J. T. Beckham, Jr.
Vice President - Nuclear
Hatch Project

HL-5146

Edwin I. Hatch Nuclear Plant - Unit 1
Inservice Inspection of
Reactor Pressure Vessel Welds

SCALE	DRAWN BY	SKETCH NUMBER
NOT TO SCALE	WS	ISI-SK-153

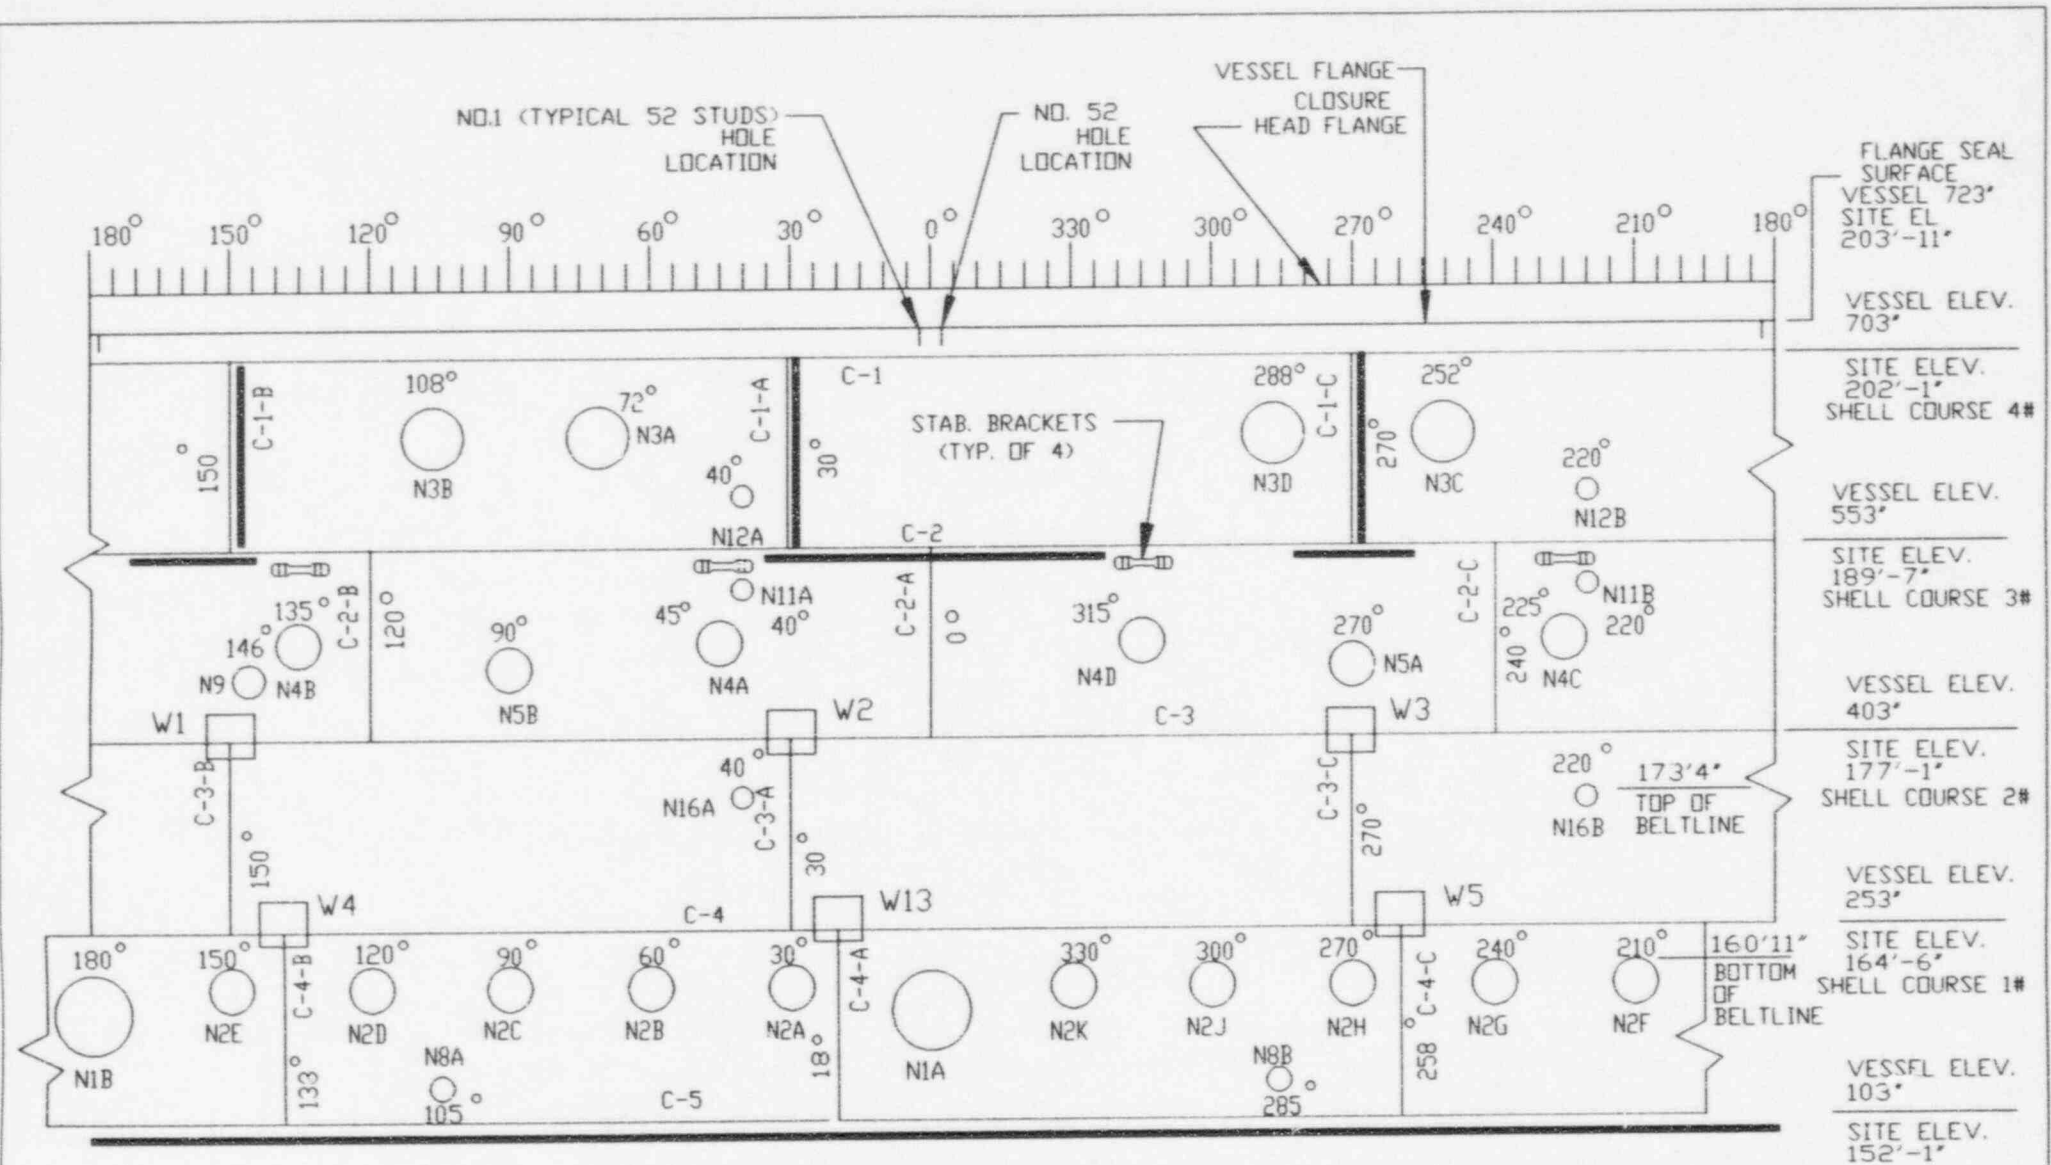
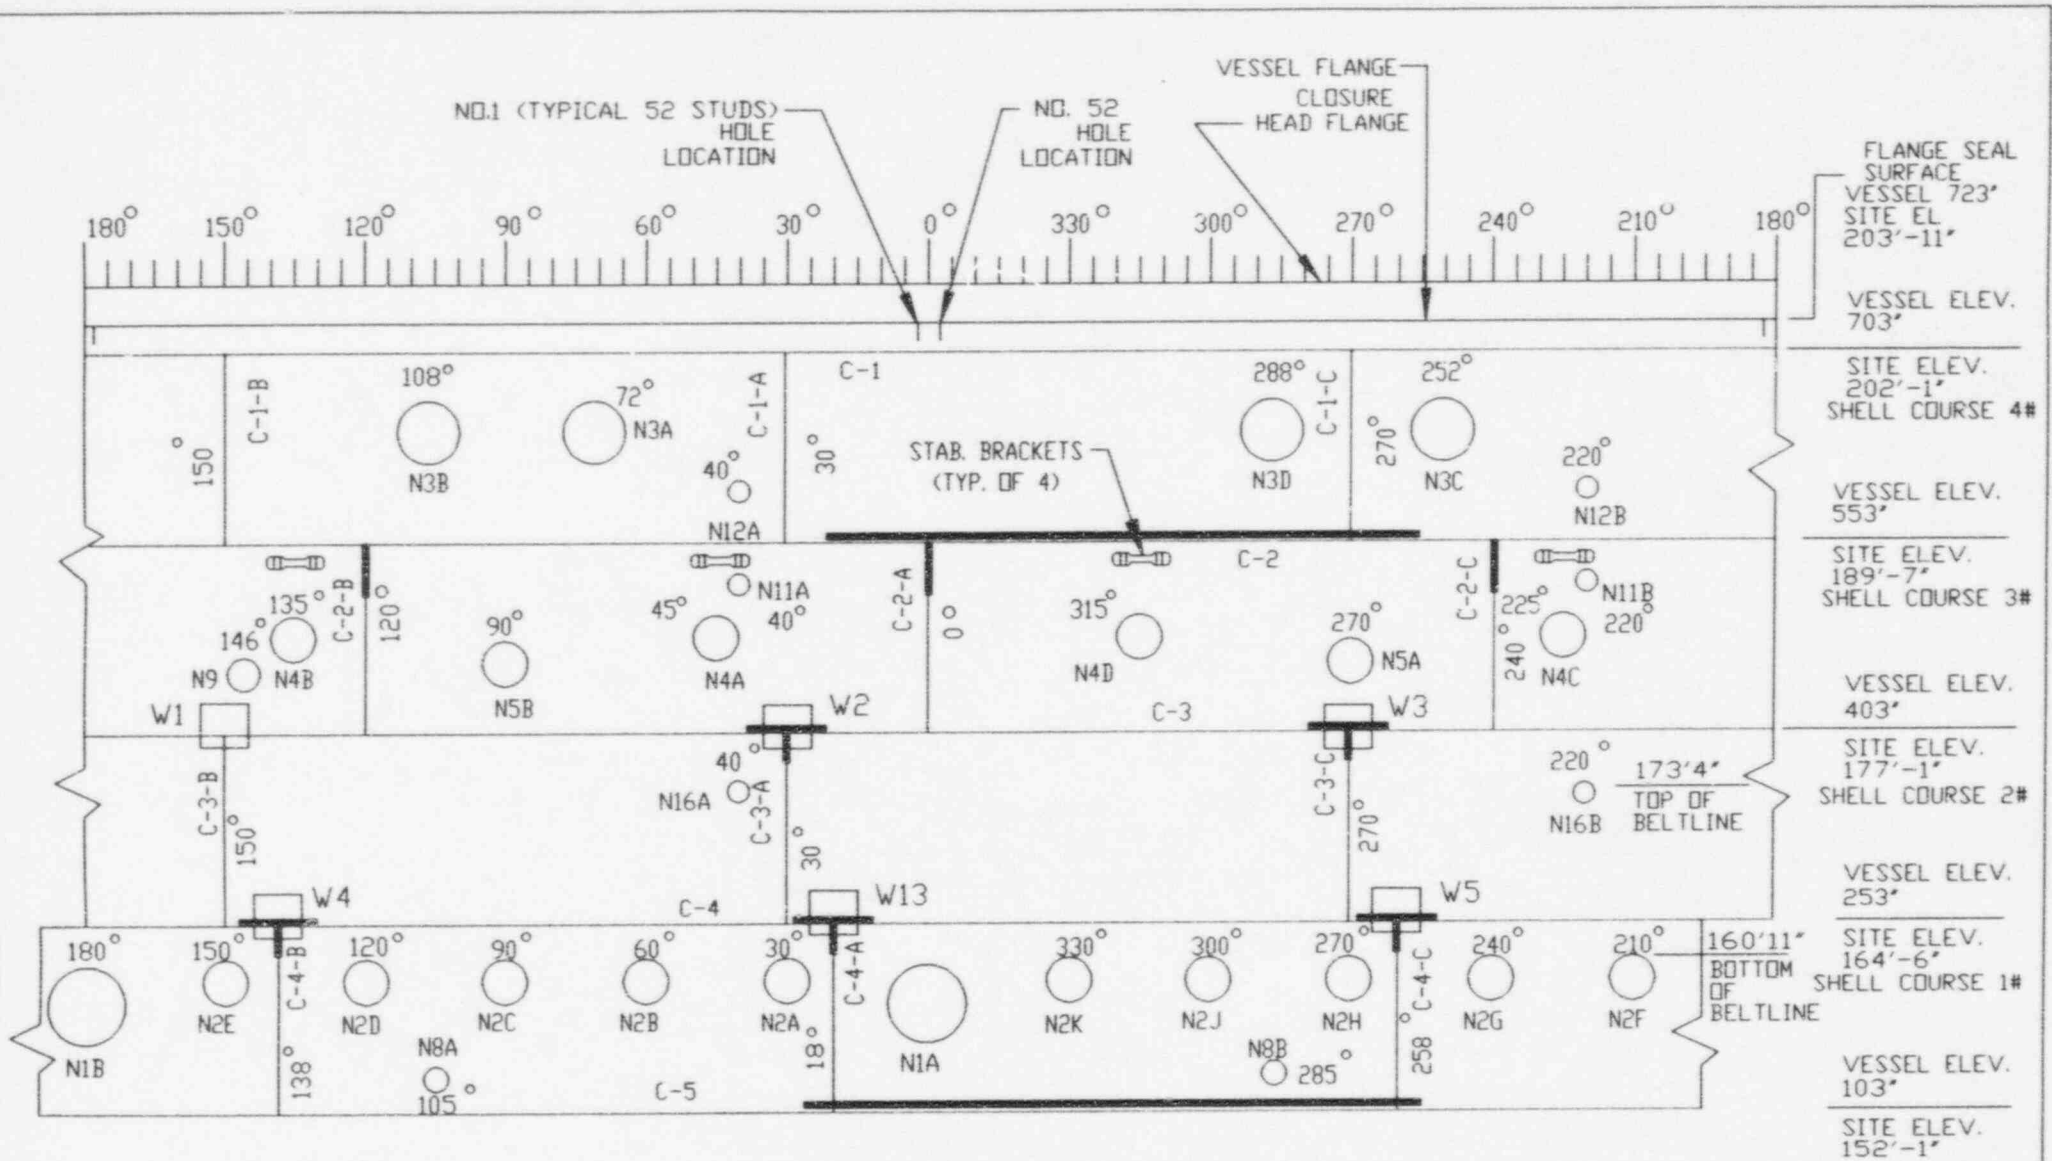
By letter dated December 4, 1995, Georgia Power Company requested that the Nuclear Regulatory Commission (NRC) staff reinstate a previous relief request concerning inspection of the reactor pressure vessel (RPV) shell welds. The relief allowed deferral of the augmented RPV examinations for Unit 1 to the first period of the third inspection interval. Also, the relief described GPC's anticipated scope of alternative examinations which included welds of the same type within and outside of the beltline region such that the equivalent examination lengths of 100 percent of one circumferential and axial beltline weld would be achieved. The anticipated scope is shown on sketch ISI-SK-154.

In recognition of as-low-as-reasonably-achievable (ALARA) principles, GPC's letter dated December 4, 1995, stated that the inspection scope was subject to revision relative to the extent to which any particular weld would be examined. The final specific scope would be determined based on ALARA. Consequently, during the Unit 1 Spring 1996 refueling outage, the inspection scope was redefined, as shown on Sketch ISI-SK-153. Based on health physics assessments of projected dose exposures for the original scope, GPC formulated an inspection scope that resolved the ALARA concerns and provided for appropriate inspections. GPC has evaluated the redefined scope and determined that the alternative examinations are acceptable. Specifically, the redefined scope results in an increase in the amount of weld examined, incorporates recent advances in technology for assessing RPV welds, and allows improved inspection techniques. Additional details are as follows:

1. The previous scope included welds which were accessible for manual examination only. The revised scope allows all examinations, circumferential and axial, to be performed using automated equipment, thereby producing more repeatable results by allowing for the electronic storage of signal data for later comparisons.
2. The amount of circumferential weld examined was equal to the equivalent length of one circumferential weld.

3. The revised scope provided a significant increase in amount of axial weld examined. This was accomplished by examining three entire axial welds as opposed to examining the equivalent length of one axial weld. This is an improvement in safety based on the BWR Vessel and Internals Project, BWR Reactor Pressure Vessel Shell Weld Inspection Recommendations (BWRVIP-05), EPRI TR-105697, dated September 1995. This analysis indicates that circumferential welds are less likely to encounter problems than axial welds.

4. Although a beltline weld was not examined, embrittlement is not an issue for Unit 1 since it has only 22 years of operation. The amount of fluence is equivalent to that of 2-3 years on a PWR. No adverse effects due to irradiation is anticipated at this point in the life of the plant.

5. The RPV contact dose rates at the three beltline inspection doors is 1.5 Rem/hr. to 1.7 Rem/hr. The configuration is such that only manual examinations could be performed and lead shielding could not be effectively used to reduce the radiation levels. In comparison, automated examinations were performed in the non-beltline area with a RPV contact dose rate of 35 mRem/hr. It is estimated that dose savings of approximately 15 Man Rem were achieved by making this change.

The change in scope for RPV shell welds inspection was based on the excessive radiation exposure to be received by performing the original examinations. The selection of these other welds has a positive impact on the safety and operation of the plant based on ALARA principles, permits the use of automated vs. manual examinations, and permits a larger sample of longitudinal welds to be examined to correspond to the findings of the BWRVIP report. Also, an RPV examination will be performed within the next forty-month period which will consist of the examination required by the NRC Augmented rule or the scope agreed to between the BWRVIP and the NRC.
